Item 7.**Development Application: 310 - 312 Cleveland Street, Surry Hills**

File No.: D/2018/742

Summary

Figure 6: The proposed ground floor (left) and first floor (right)

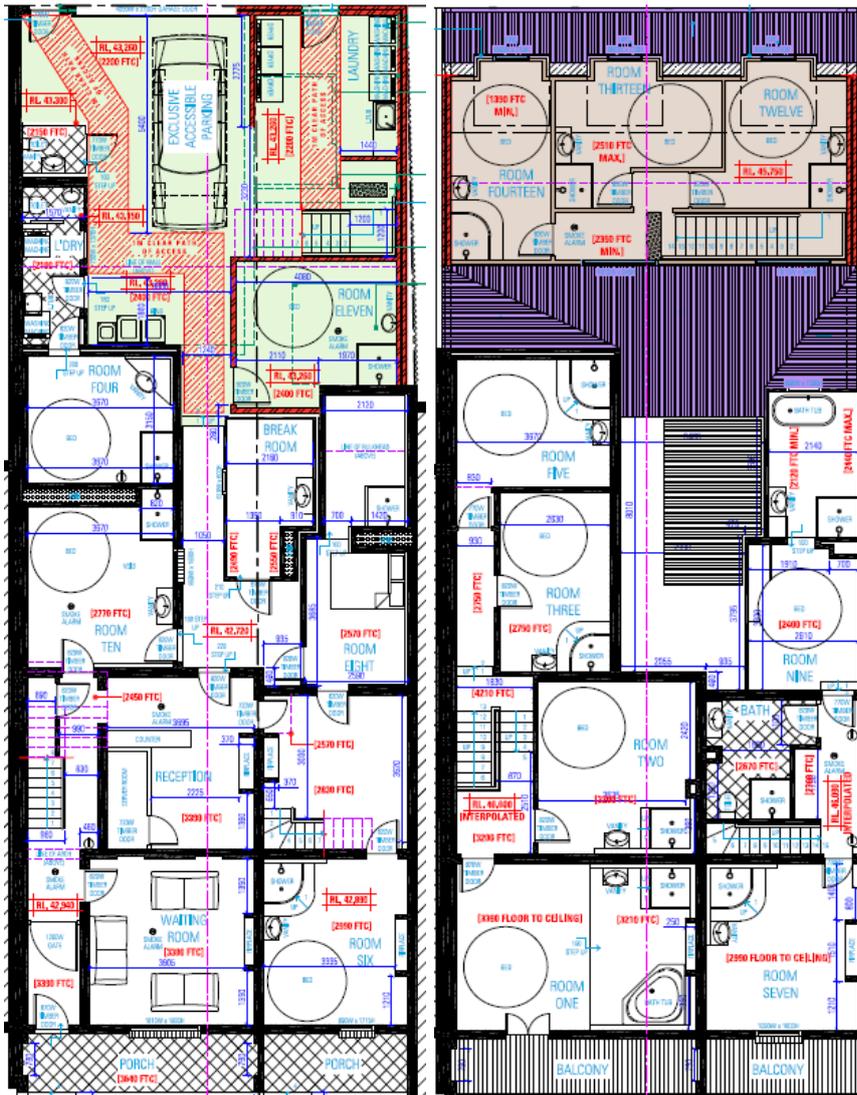
29. The application was referred to the City's Heritage Specialist who requested the addition of three lightweight parapet walls to frame the boundaries of the lots and to allow the original subdivision pattern to be discerned, and the symmetrical arrangement of the dormer windows to Goodlet Lane.

30. In response to these concerns, the applicant submitted amended plans detailing parapets extending 300mm above the roof cladding and 240mm in width, with the dormer windows symmetrically placed on the roof plane.

Figure 8: The proposed south-east elevation of the rear addition

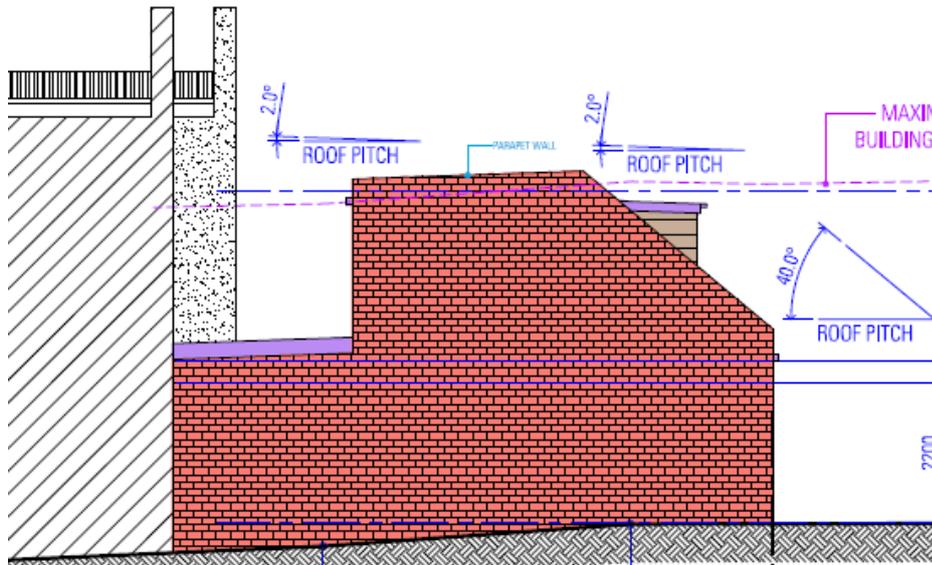
31. Section 4.1.6.1 of the Sydney DCP 2012 prescribes a maximum height of 5.4m for secondary or laneway dwellings. While this Section of the Sydney DCP 2012 does not apply to commercial development, the proposal presents to Goodlet Lane such that it reads as this building typology. The proposed rear addition is below 5.4m, with the exception of parapet walls, which results in a minor exceedance to the height control of 0.2m. The non-compliance is considered acceptable as it results in an improved design and heritage outcome.
